# UNITED STATES PATENT AND TRADEMARK OFFICE

09/892,790

***Examiner's Response to Clarification Request of Board of Patent Appeals  
and Interferences***

Examiner marked-up copy of Fig. 5c  
of Nepela (US 5,568,981)

Fig 5c

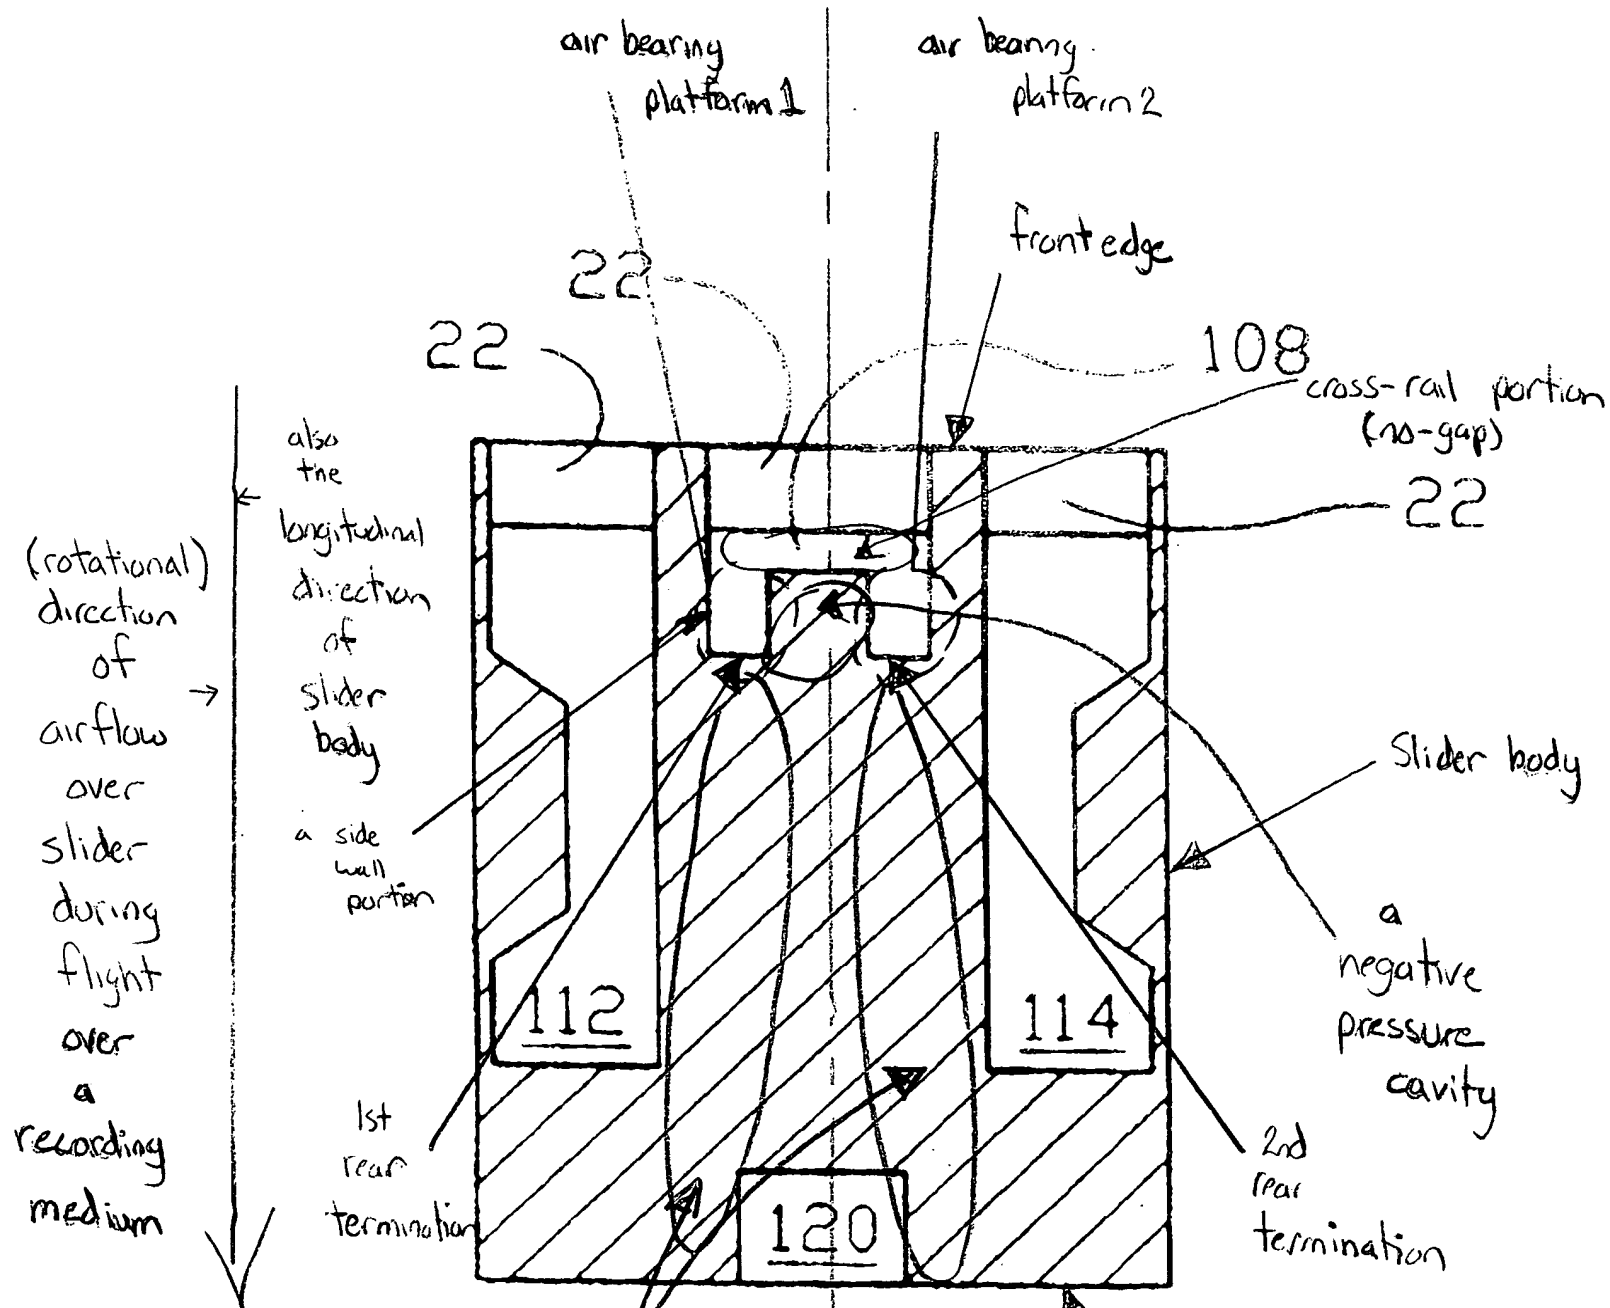
shaped air bearing platform (108) comprising not more than two separate air bearing platforms (e.g., the left side leg of the U-shaped air bearing as seen in FIG. 5c and the right side leg of the U-shaped air bearing as seen in FIG. 5c - the platforms joined by a cross-rail extending normal to the longitudinal direction of the slider), said platforms each extending rearwardly toward said rear portion of said principal surface and respectively terminating at a first rear termination and a second rear termination (see Examiner's marked-up copy of FIG. 5c, appended herewith), at least one of said not more than two separate air bearing platforms including a side wall portion (e.g., vertical wall surface extending from the air-bearing surface of the air bearing platform 1 or 2, to the bottom principal surface); at least one of said first rear termination and said second rear termination not coinciding with said rear edge (e.g., please note that the 1<sup>st</sup> and 2<sup>nd</sup> rear terminations do not extend to the rear edge - see Examiner's marked-up copy of FIG. 5c, appended herewith), and being disposed upstream of said rear edge relative to said rotational direction of said recording medium - again, please see Examiner's marked-up copy of FIG. 5c, appended herewith.

first plane tangential to a first direction (e.g., the plane of the aforementioned principal surface excluding the platform rails, indicated in diagonal cross-hatch, e.g., in Fig. 5c, with the first [longitudinal] direction being indicated in the Examiner's marked-up copy of FIG. 5c, appended herewith); said principal surface having a lead portion (e.g., a portion or any portion for that matter, of the slider body that is disposed toward the conventional leading edge of the slider) and a rear portion (e.g., a portion or any portion for that matter, of the slider body that is disposed toward the conventional rear edge of the slider and downstream of the aforementioned lead portion), said lead portion being spaced upstream from said rear portion relative to said first direction (e.g., the longitudinal direction, with the initial airflow that impinges on tapers (22), from the leading edge of the slider, to the slider trailing edge), said lead portion having a front edge - again, please see Examiner's marked-up copy of FIG. 5c of Nepela (US 5,568,981) appended herewith), said rear portion having the aforementioned rear edge, said front edge and said rear edge together defining longitudinal boundaries of said principal surface in said first direction (as can be readily seen with reference to FIG. 5c); and said U-shaped air bearing platform (108) having a plurality of air bearing surfaces surrounding a negative pressure cavity (e.g., the recessed pocket located between the aforementioned air bearing platform 1 and air bearing platform 2) while defining a second plane tangential to said first direction (note that this "second plane" is a plane that is located within the plane of the raised air bearing platform above the principal surface, and along the first or longitudinal direction as seen in the marked-up copy of FIG. 5c of Nepela (US 5,568,981), said U-shaped air bearing platform comprising not more than two separate air bearing platforms (e.g., the left side leg of the U-shaped air bearing as seen in FIG. 5c and the right side leg of the U-shaped air bearing as seen in FIG. 5c - the platforms

joined by a cross-rail extending normal to the longitudinal direction of the slider), each platform extending from said lead portion rearwardly toward said rear portion and respectively terminating at the aforementioned and depicted in marked-up form, first rear termination and a second rear termination, at least one of said not more than two separate air bearing platforms including a side wall portion - see marked-up copy of FIG. 5c of Nepela (US 5,568,981); at least one of a surface (i.e., the principal surface of the diagonal cross-hatch behind the 1<sup>st</sup> and 2<sup>nd</sup> rear terminations) between said first rear termination and said rear edge and a surface between said second rear termination and said rear edge being in said first plane (e.g., the plane of the surface excluding the platform rails, indicated in diagonal cross-hatch, e.g., in Fig. 5c - please see Examiner's marked-up copy of Nepela (US 5,568,981) enclosed herewith).

E.g., please note that the left side leg of the U-shaped air bearing as seen in FIG. 5c and the right side leg of the U-shaped air bearing as seen in FIG. 5c - are the platforms joined by a cross-rail extending normal to the longitudinal direction of the slider, which is completely consistent with the Examiner claim language interpretation with regard to another independent claim - claim 21 - and is also completely consistent within the context of the Appellant's drawings and specification.

claim 31:  
 - "at least one of  
 a surface between said  
 first rear termination and  
 said rear edge and a surface  
 between said second rear termination  
 and said rear edge → being in  
 said 1st (cross-hatched) plane"

↑  
 longitudinal  
 axis  
 of  
 slider
